BID ADDENDUM NO. 1

December 15, 2025

Corning-Painted Post Area School District
2025 Bus Garage, Admin & Stadium Alterations
2649.154

The following Addendum items shall be considered as part of the contract documents prepared by HUNT ENGINEERS, ARCHITECTS, LAND SURVEYORS & LANDSCAPE ARCHITECT, DPC.
Bid Document date of 11/13/2025.

1 ROOF HVAC DEMOLITION PLAN
1/8" = 1'-0"

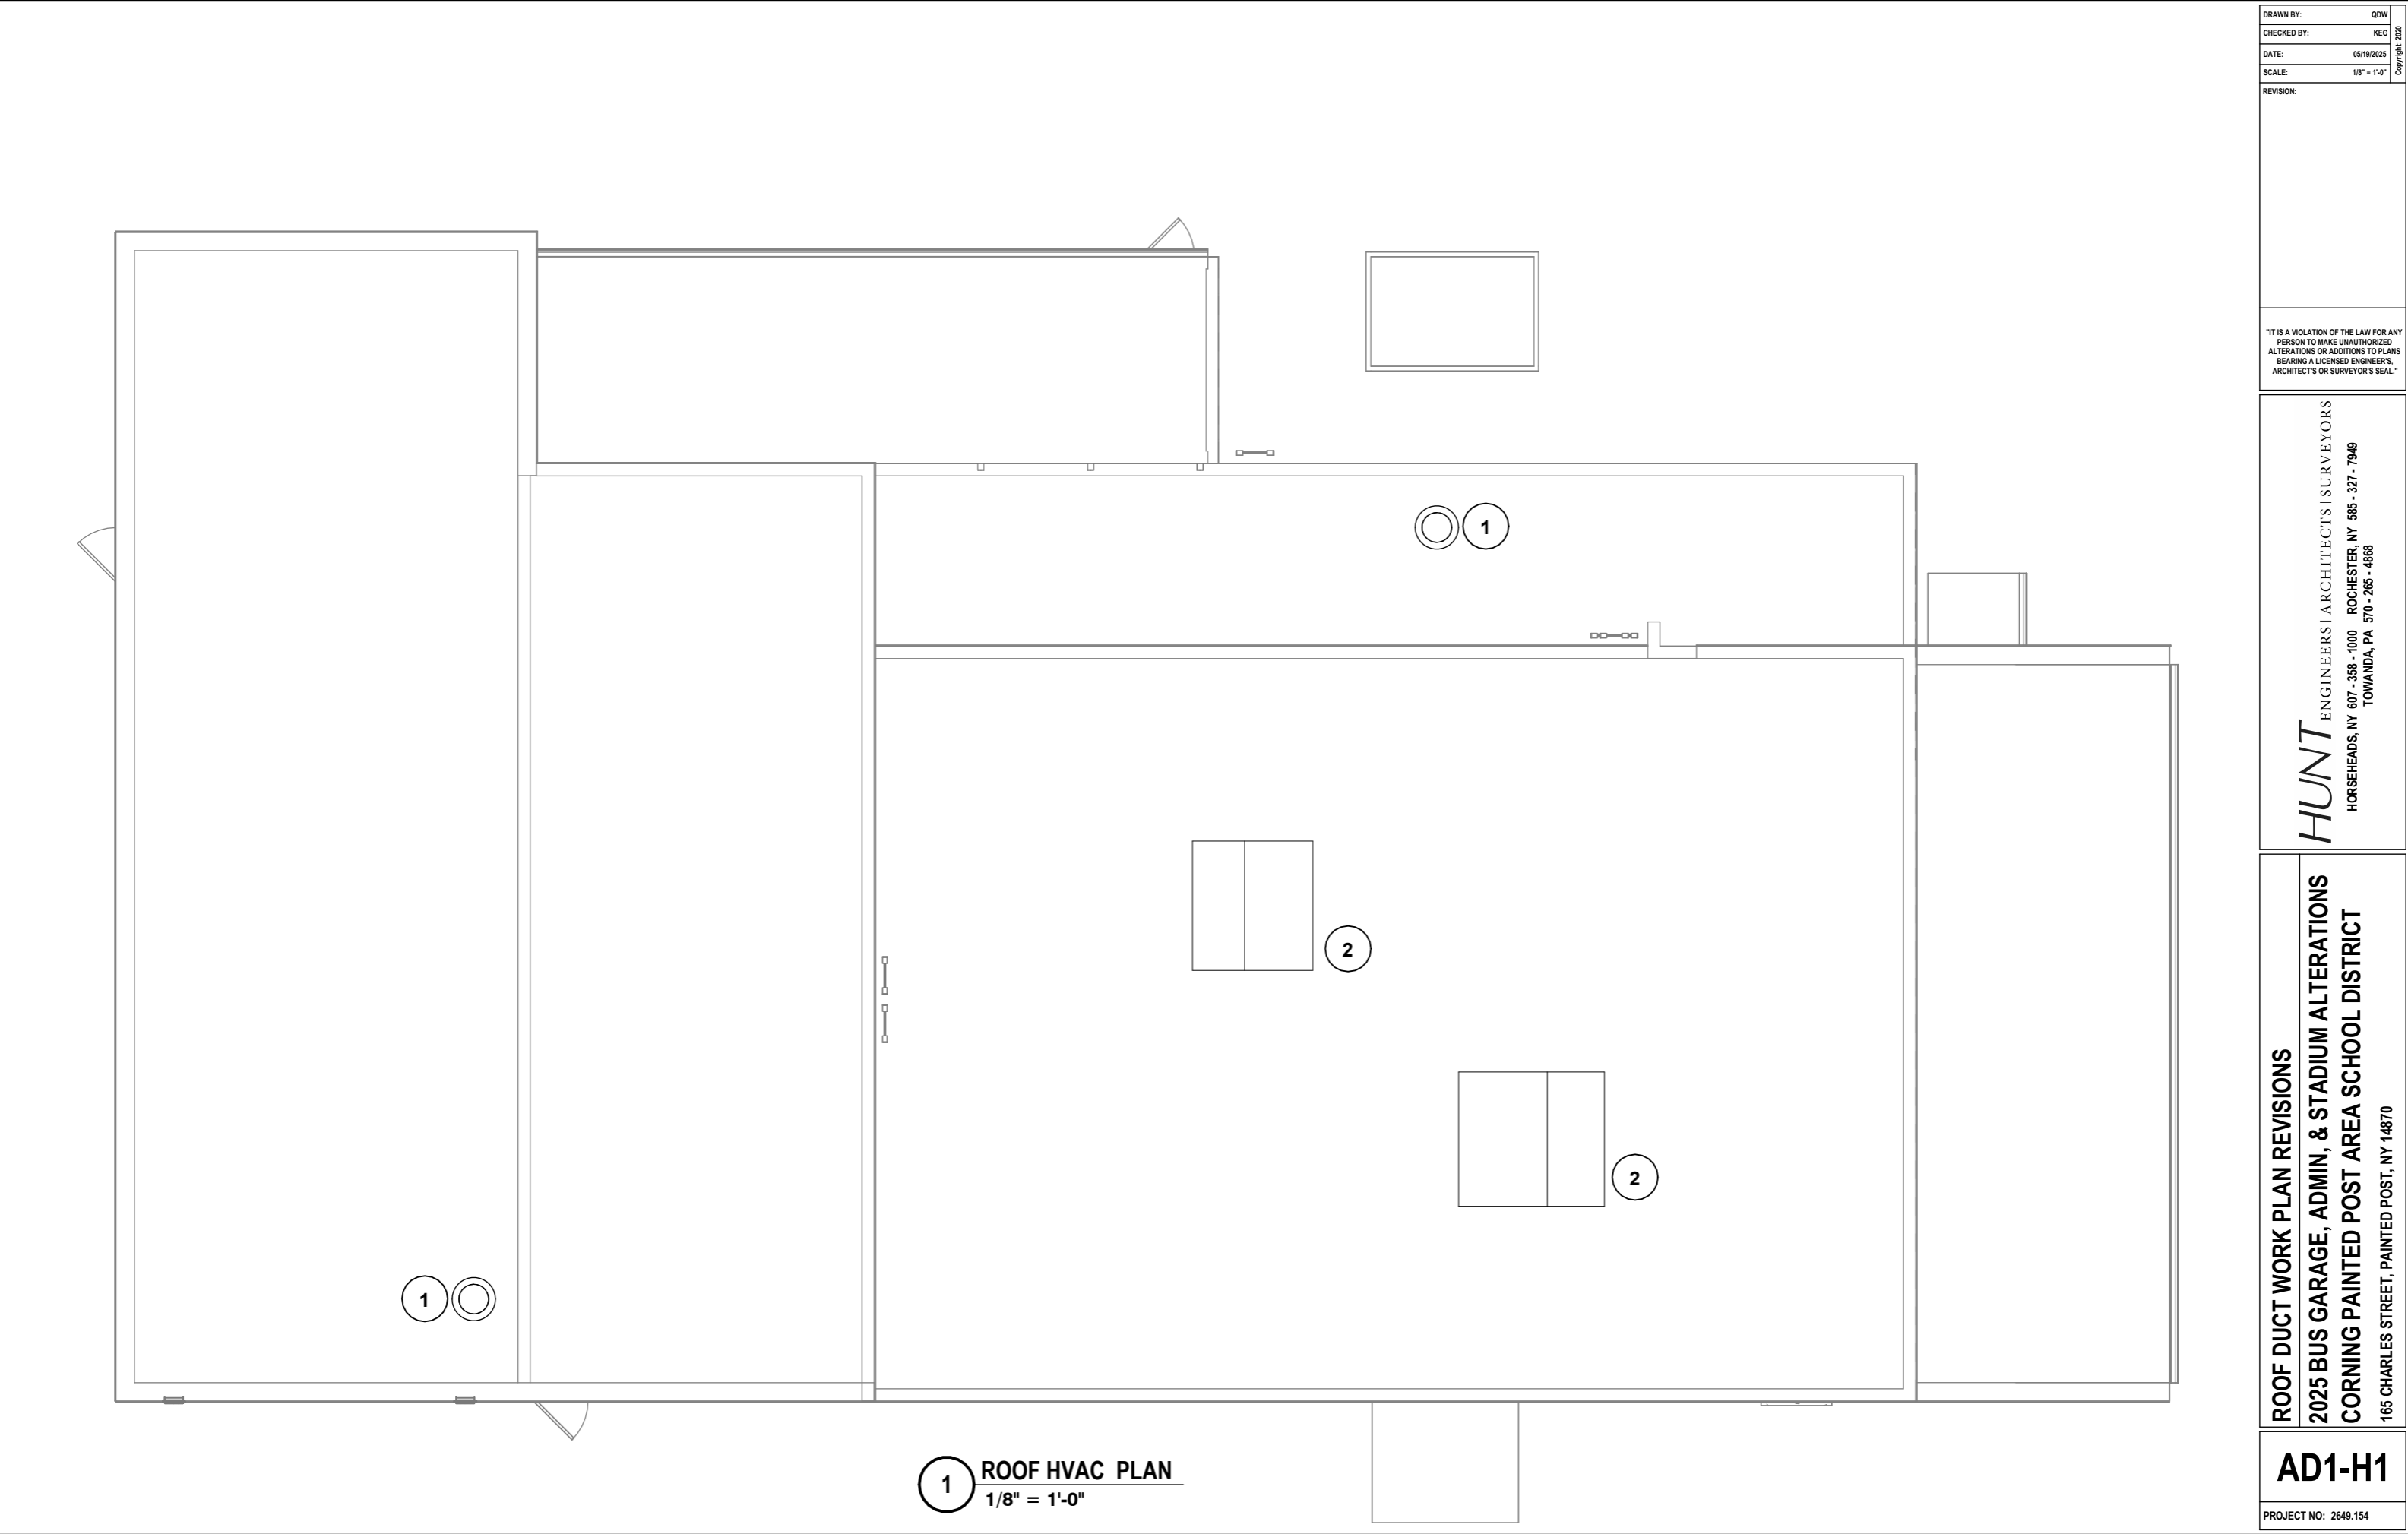
ITEM AD1-4 Refer to BG-H1.1 – ROOF HVAC PLANS
AMEND Detail 1 with AD1-H2 ROOF HVAC DEMO PLAN REVISIONS as issued by this addendum.

ROOF HVAC DUCT WORK PLAN - AREA B REVISIONS

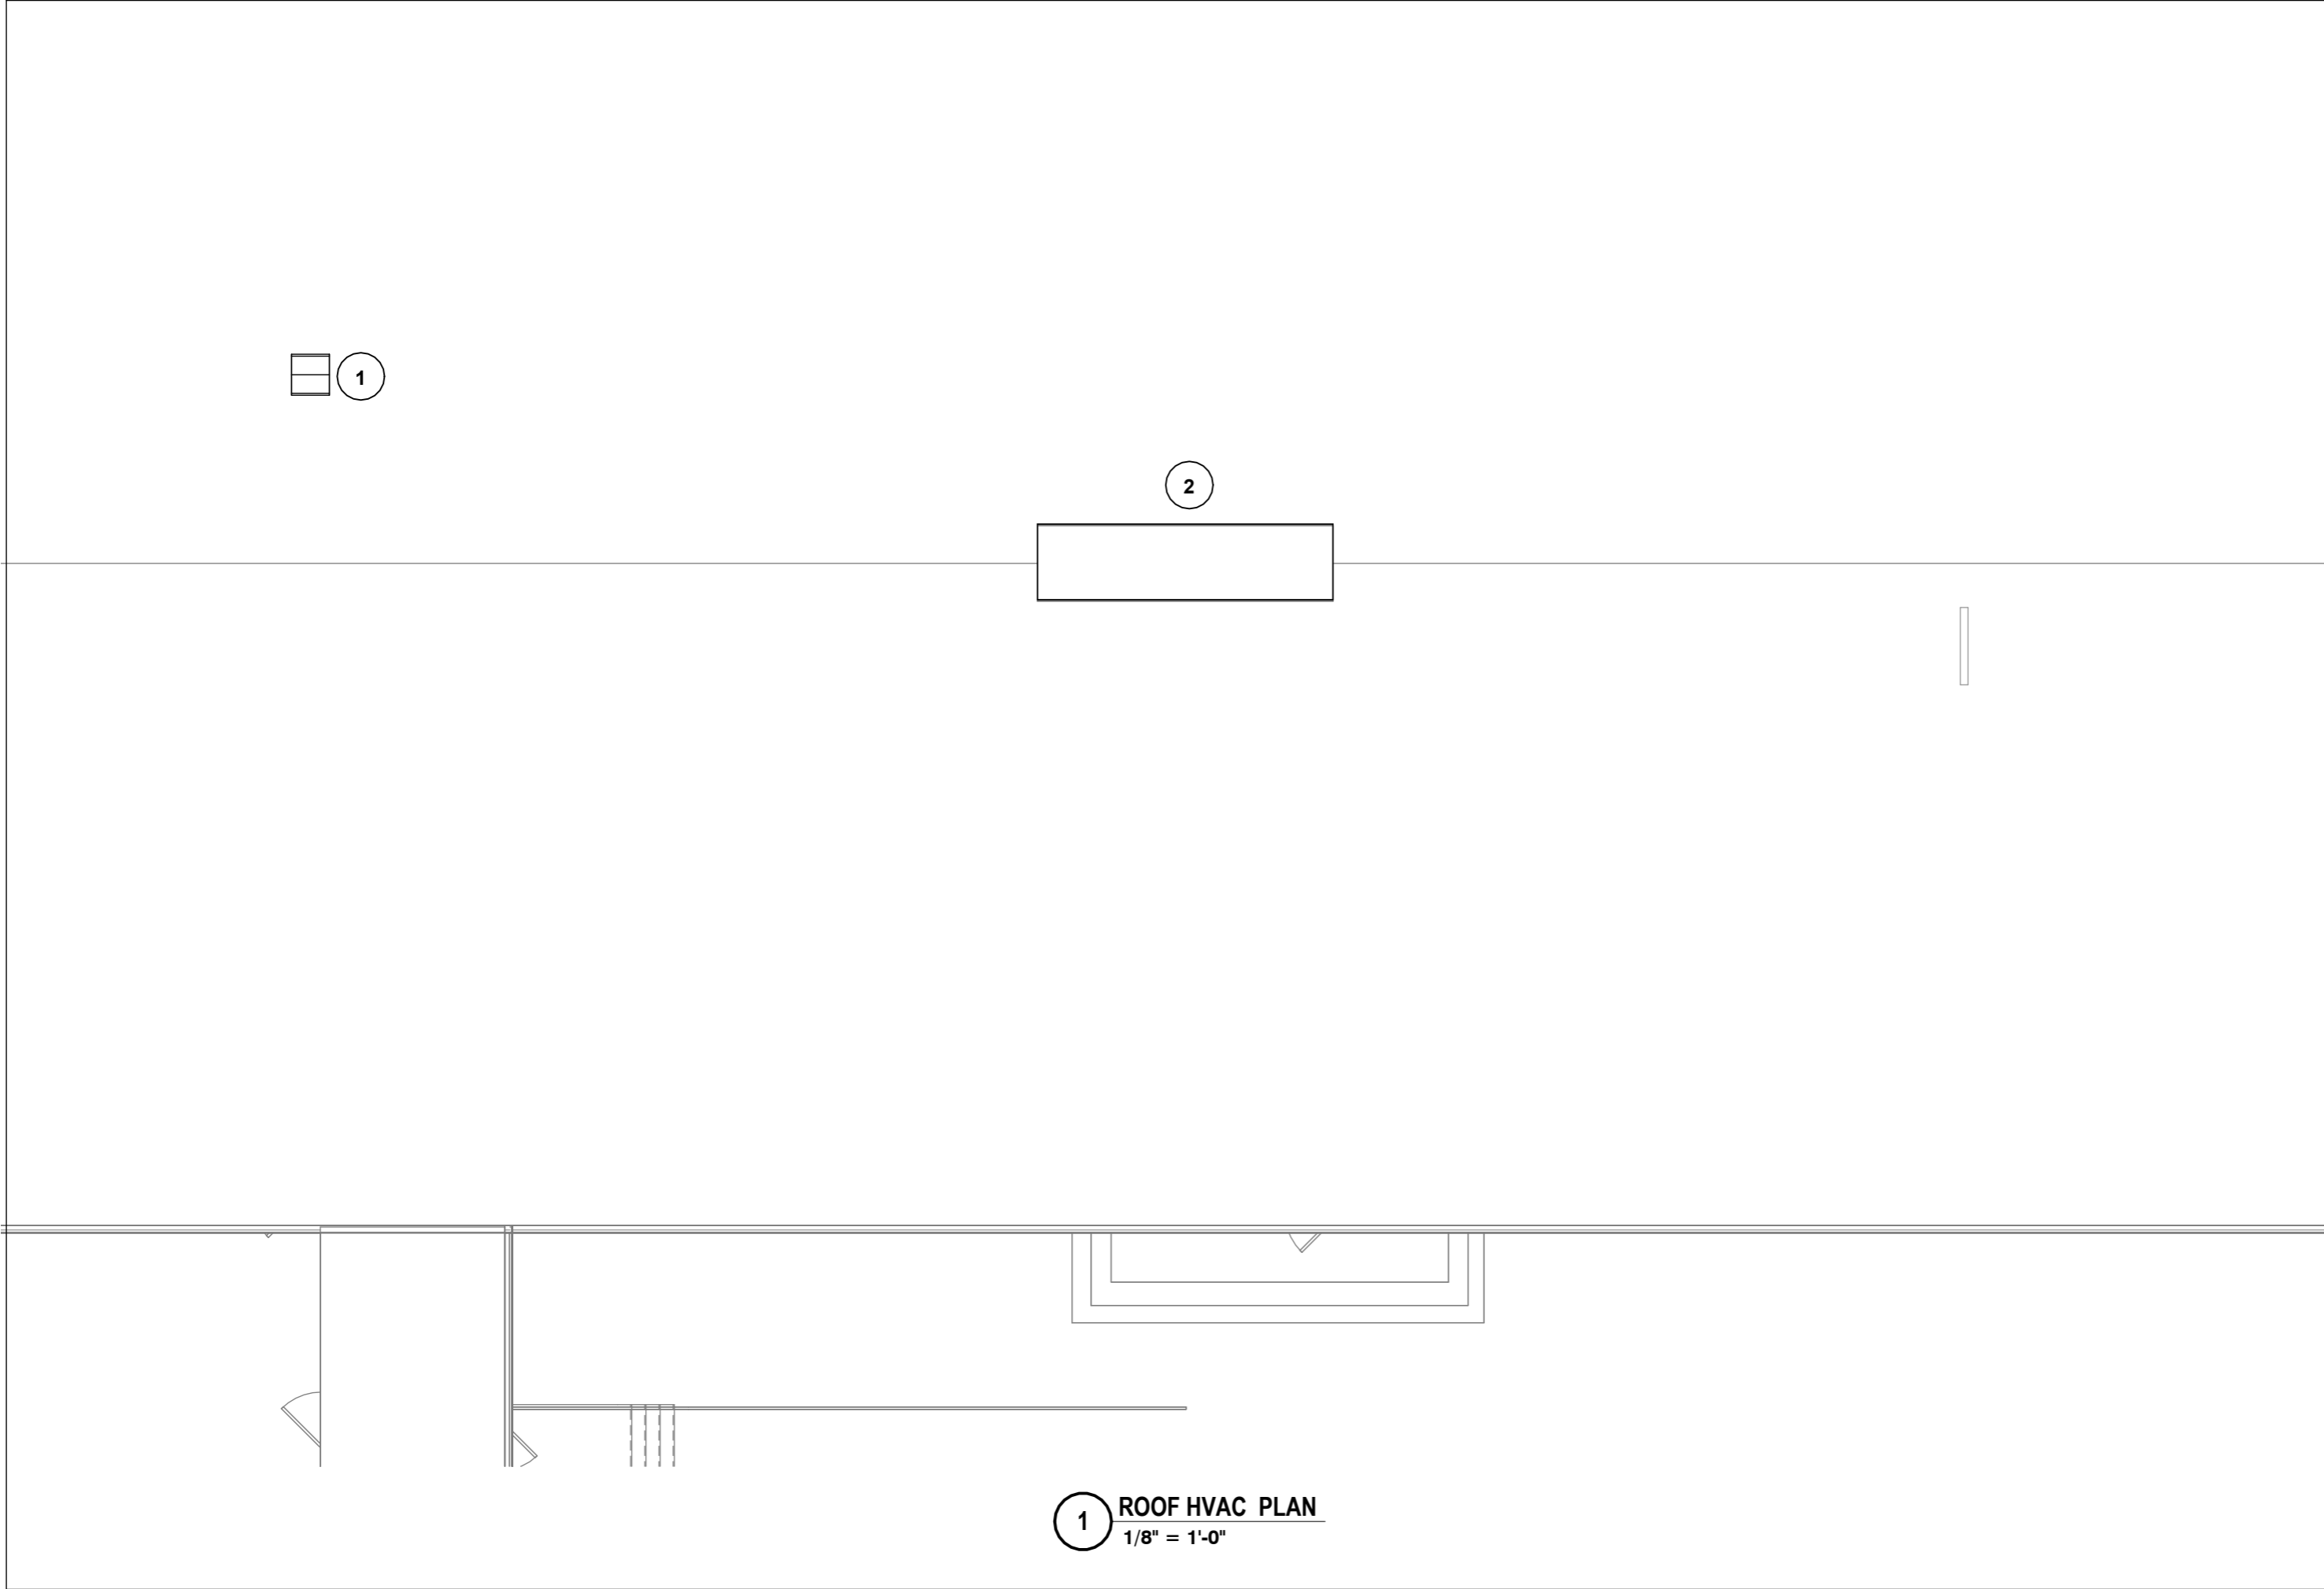
ITEM AD1-13 Refer to AD-H1.1 – ROOF HVAC PLAN

AMEND Detail 2 with AD1-H3 ROOF HVAC DUCTWORK PLAN REVISIONS as issued by this
addendum.

ROOF HVAC DEMO PLAN - AREA B REVISIONS

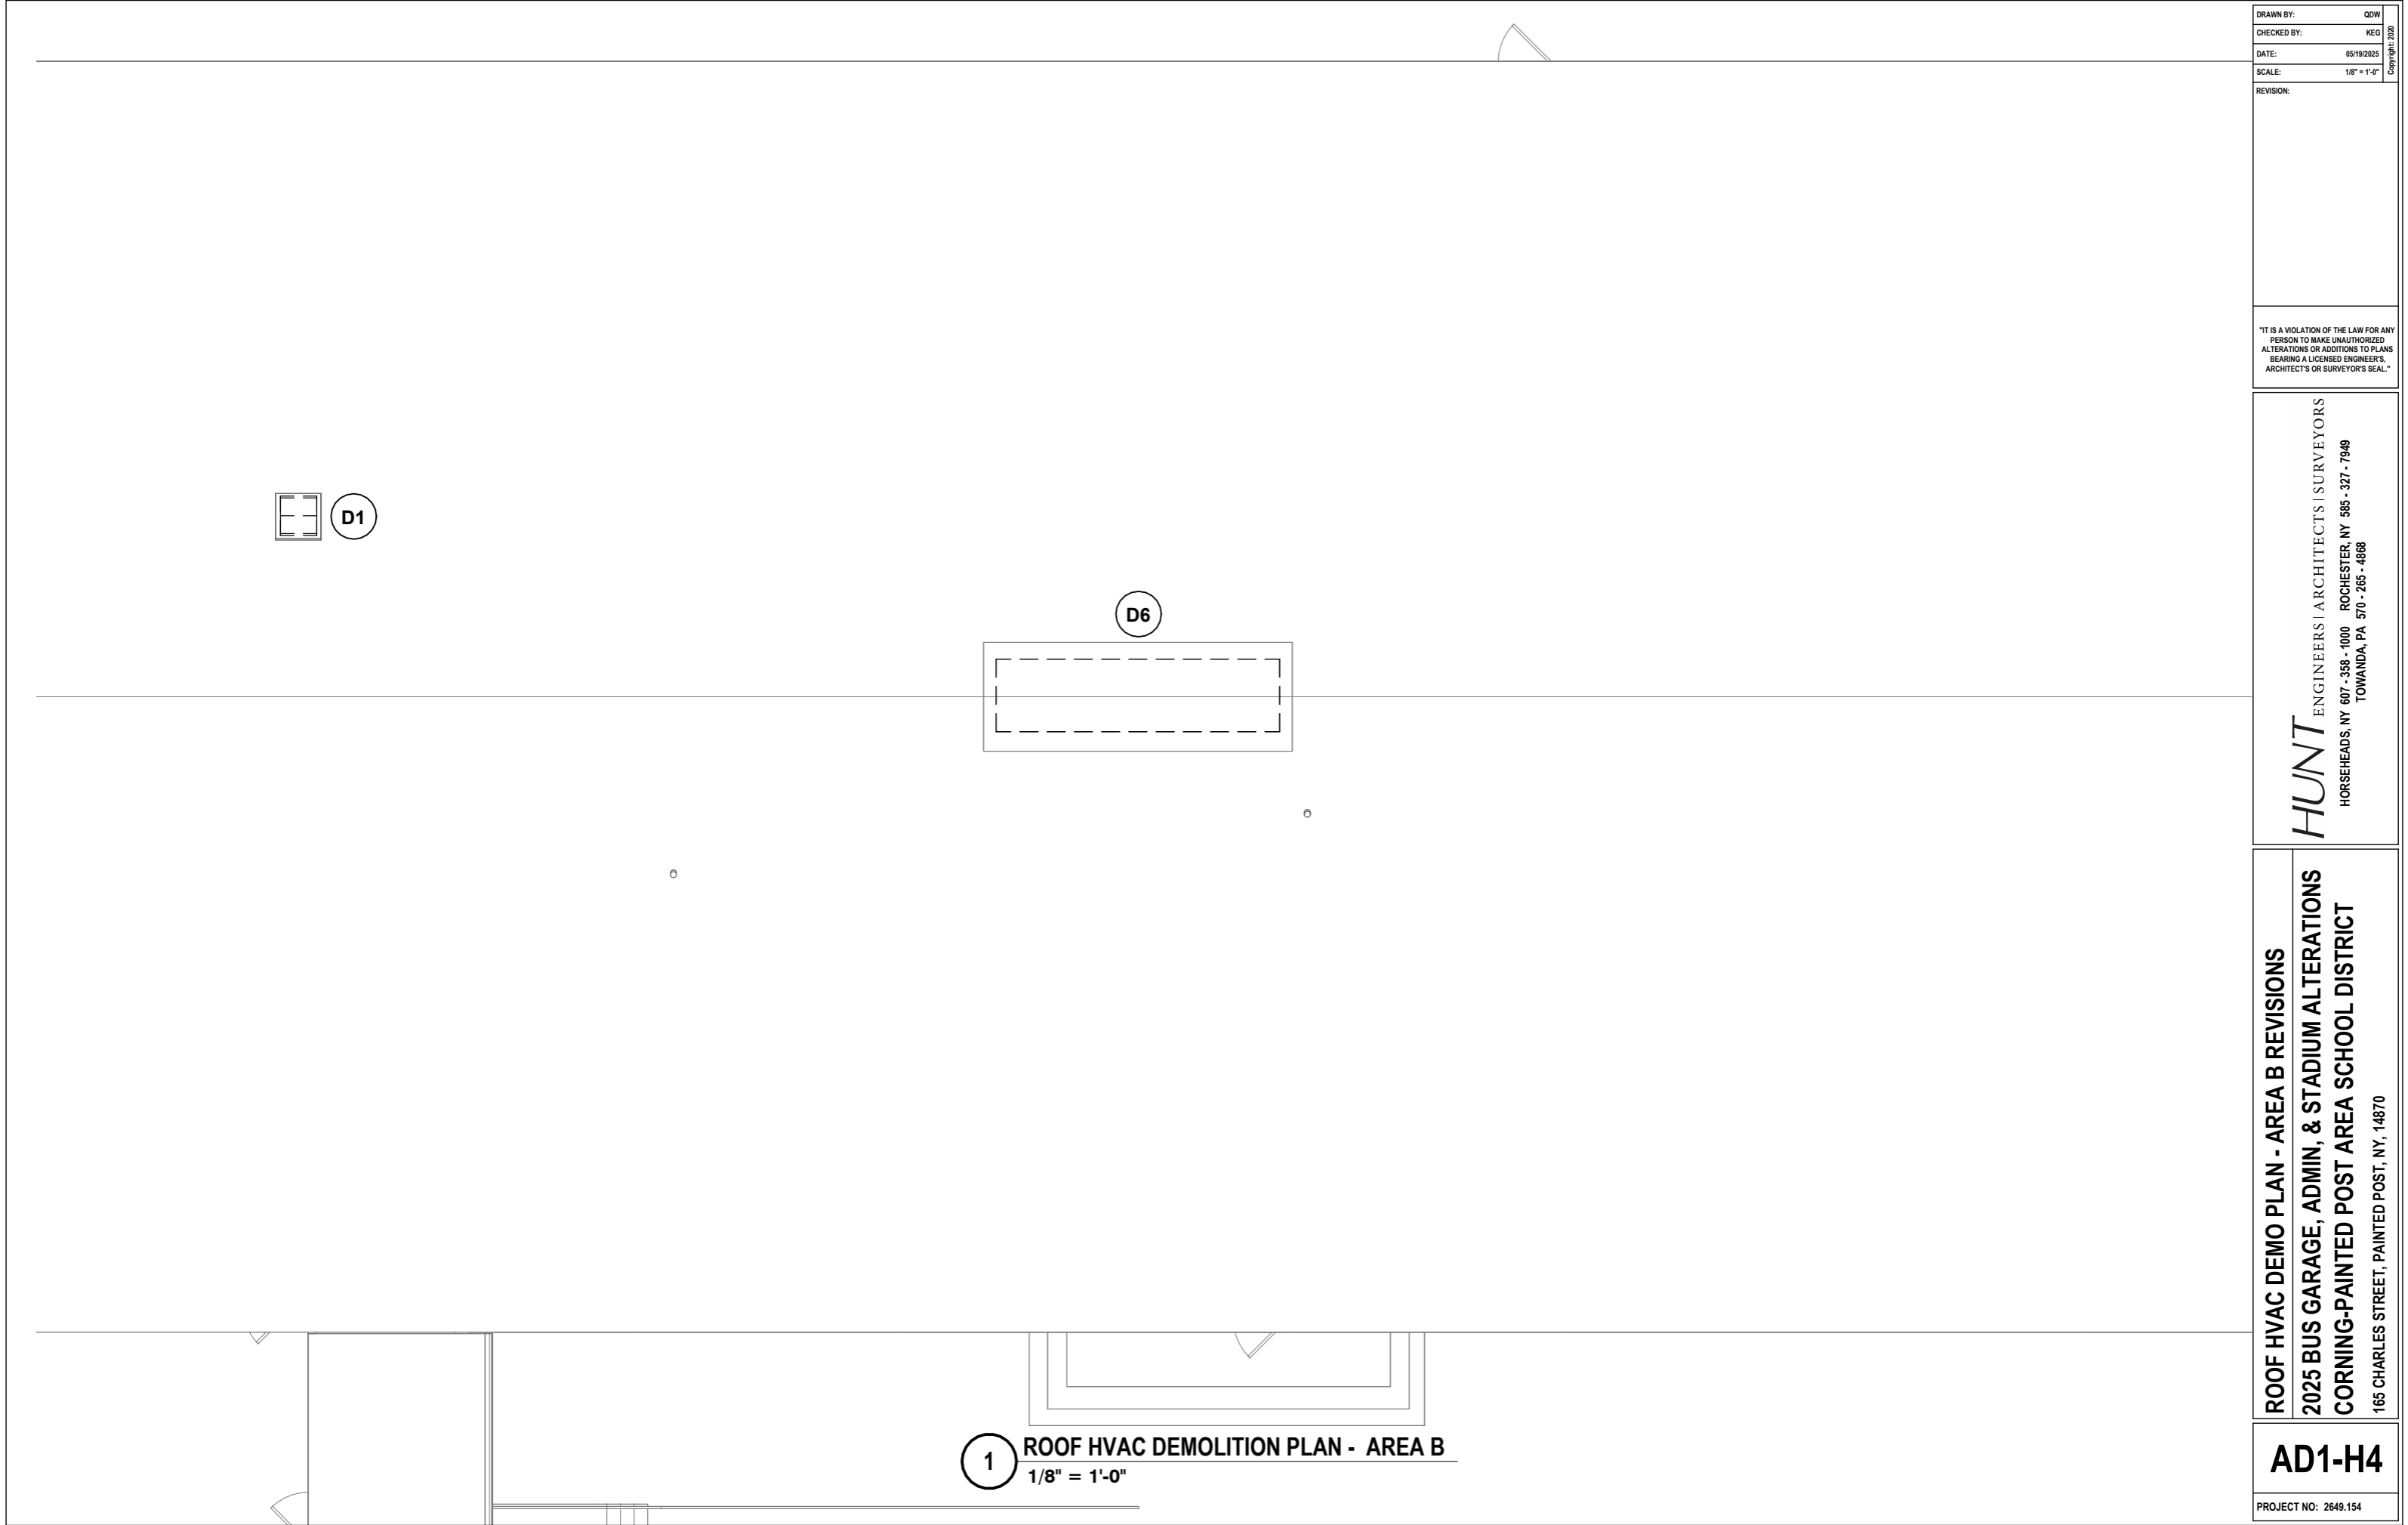
ITEM AD1-14 Refer to AD-H1.1 – ROOF HVAC PLAN

AMEND Detail 1 with AD1-H4 ROOF HVAC DEMO PLAN – AREA B REVISIONS as issued by
this addendum.
